<p>SUNDRY NOTICES AND REPORTS ON WELLS (DO NOT USE THIS FORM FOR PROPOSALS TO DRILL OR TO DEEPEN OR PLUG BACK TO A DIFFERENT RESERVOIR. USE "APPLICATION FOR PERMIT" (FORM C-101) FOR SUCH PROPOSALS.)</p> <p>1. Type of Well: Oil Well <input type="checkbox"/> Gas Well <input checked="" type="checkbox"/> Other</p> <p>2. Name of Operator GREAT WESTERN DRILLING COMPANY</p> <p>3. Address of Operator 700 W. LOUISIANA, MIDLAND, TEXAS 79701</p> <p>4. Well Location Unit Letter <u>P</u> : 660 feet from the <u>SOUTH</u> line and 660 feet from the <u>EAST</u> line Section 27 Township 13S Range 31E NMPM County CHAVES</p>		<p>5. Indicate Type of Lease STATE <input type="checkbox"/> FEE <input type="checkbox"/></p> <p>6. State Oil & Gas Lease No. NM-04365</p> <p>7. Lease Name or Unit Agreement Name ROCK QUEEN UNIT</p> <p>8. Well Number 34</p> <p>9. OGRID Number 9338</p> <p>10. Pool name or Wildcat CAPROCK; QUEEN</p>

At the request of the BLM, Great Western Drilling Company asks, respectfully, for approval to plug and abandon the Rock Queen Unit #34 well.

NMNM-71025X8. Well Name and No. **ROCK QUEEN UNIT #34**9. API Well No. **30-005-00887**10. Field and Pool or Exploratory Area
CAPROCK; QUEEN11.

ROCK QUEEN UNIT #34 - PROPOSED as of 2026_01_21

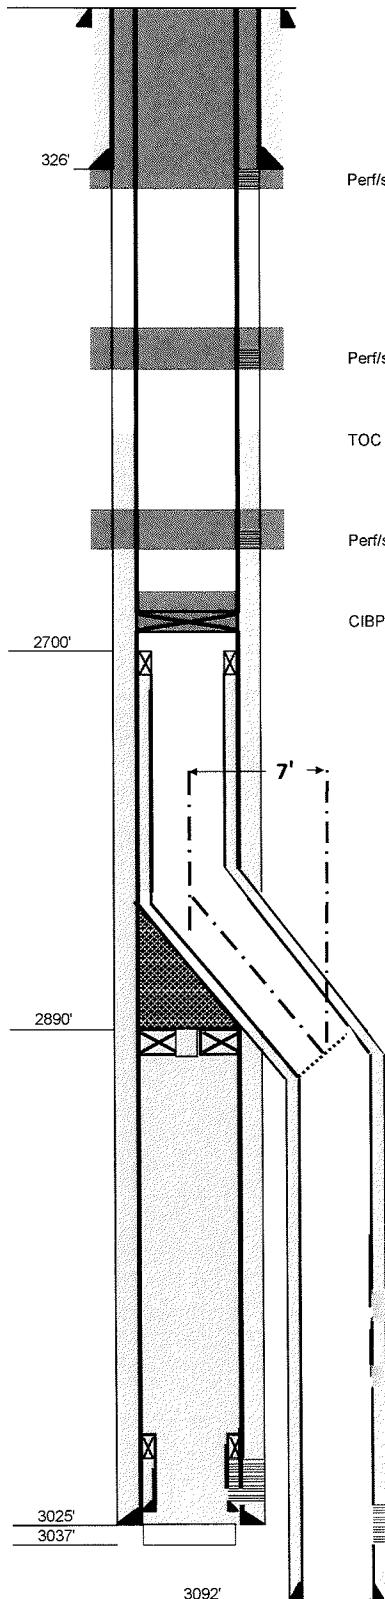
Revision to Phase 1 procedure w/ added Phase 2 P&A procedure:

1. RU WL CIBP at 2,650' load and circulate well.
2. Run CBL from 2,650' to surface.
3. Spot 30 sxs 2650' tag at 2,350' (7 Rivers).
4. MUH spot 25 sxs 2,377-2120' (Yates, Salt).
5. Spot 25 sxs 1557-1307 (Salt, Anhydrite).
6. Perf and squeeze at 365' 80 sxs to surface (Casing Shoe).
7. Cut off well head, install dry hole marker

1. Operator shall set CIBP at 2,650'. Operator shall place 25 sx Class C cement on top. WOC and TAG.

Note: the well has been sidetracked. Liner top is at 2,700' the original hole had a cement retainer placed and cement pumped down prior to the sidetrack. TOC is noted at 1,990'.

2. Operator shall perf at 2,335' and squeeze cement to 2,210' to isolate the top of the Yates and the bottom of the Salt. WOC and TAG.
3. Operator shall perf at 1,559' and squeeze cement to 1,307' to isolate the top of Salt and Rustler. WOC and TAG.
4. Operator shall perf at 365' and squeeze cement class C cement to surface to seal the 8-5/8" casing. WOC and TAG.
5. Dry hole marker must be below ground.
6. Surface reclamation will need to be completed once the well bore has been plugged. Please contact rflores@blm.gov for additional information.
7. See Attached for general plugging stipulations.
